Subject: Independent School District #834
Submittal to City of Lake Elmo on behalf of Stillwater Area Public Schools, for the proposed New Lake Elmo Elementary School project, located at the intersection of Lake Elmo Avenue North and Tenth Street North, Lake Elmo, Minnesota (Property ID #2602921440001)

Comprehensive Plan Amendment and Zoning Map Amendment Submittal Narrative:

NEW LAKE ELMO ELEMENTARY SCHOOL

01/19/2024 - LAKE ELMO ELEMENTARY
 ZONING MAP AMENDMENT SUBMISSION
(CONCEPTUAL PLAN - DO NOT USE FOR CONSTRUCTION)

**CONCEPTUAL -
LANDSCAPING
PLAN**

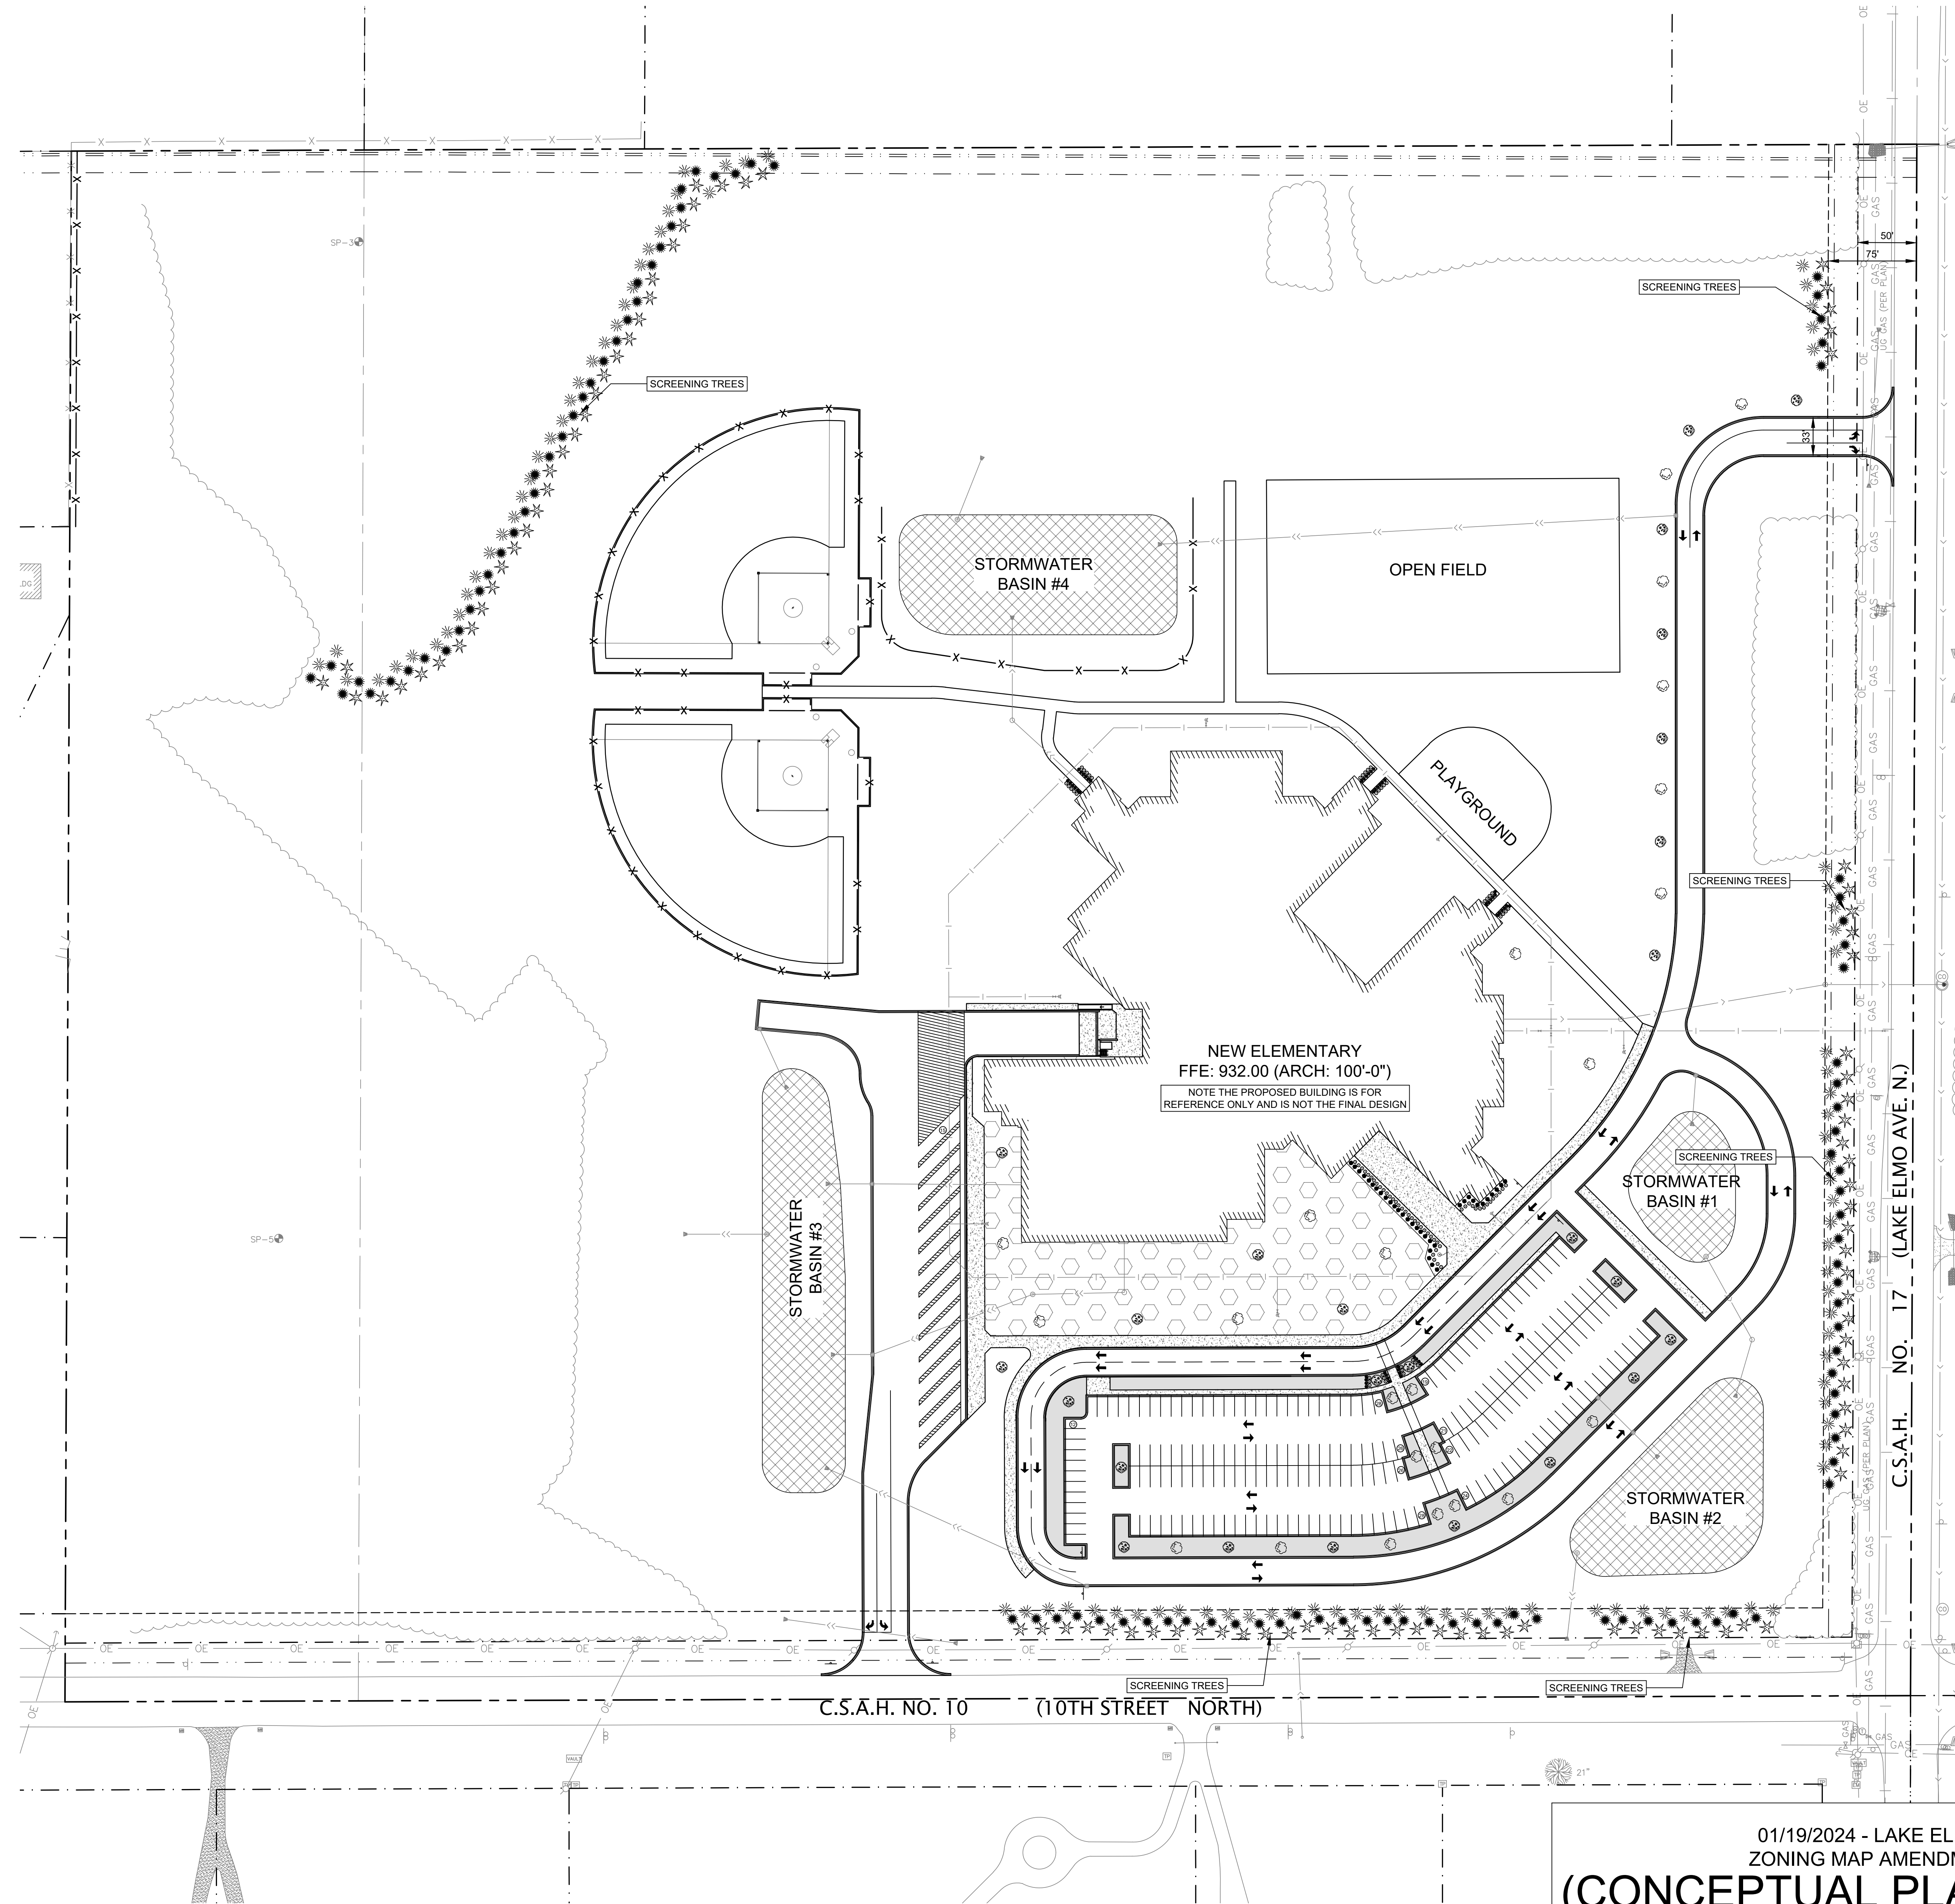
- j. *Landscaping*- No landscaping or screening of the property will be allowed in the current or future county right of way. All landscaping should be included on the school property.
- k. *Noise and Lighting*- County highway traffic produces noise that should be considered in the site design. Similarly – lighting can be a key safety element and lighting should be considered as part of the site planning.
